**From:** Raymond Detter  
**Sent:** Thursday, January 03, 2013 9:04 PM  
**To:** Planning  
**Subject:** 401-413 E. Huron Street Proposal

**401-413 East Huron Street Proposal**  
**Comments of the Downtown Design Guidelines Citizens Review Committee**  
3 January 2013

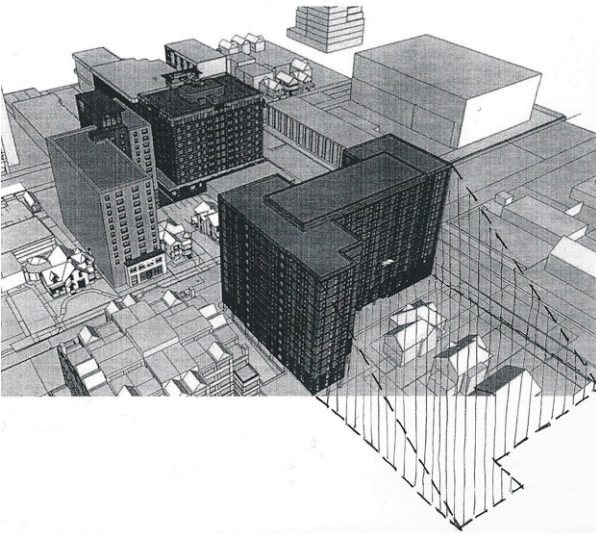
Many of the city's Design Guidelines have been ignored in the design of this project. According to the Guidelines, new buildings in this district should be seen "in the round," with open space surrounding them. The Guidelines (Section 3c) state, "Generally, structures are set back from the sidewalks, with landscaping in the foreground, either in the form of a lawn or landscaped plaza or planter." This setback and landscaping, similar to what is seen on the Sloan Plaza and Campus Inn properties, is not included in the proposal. The pedestrian way, with a six-foot width, is too narrow for a major street.

The Design Guidelines also recommend (Section A.2.2) "*Site designs should accommodate solar access and minimize shading of adjacent properties and neighborhoods.*"

A solar shadow analysis illustrates this project will have very harmful impact on residential properties to its north side.
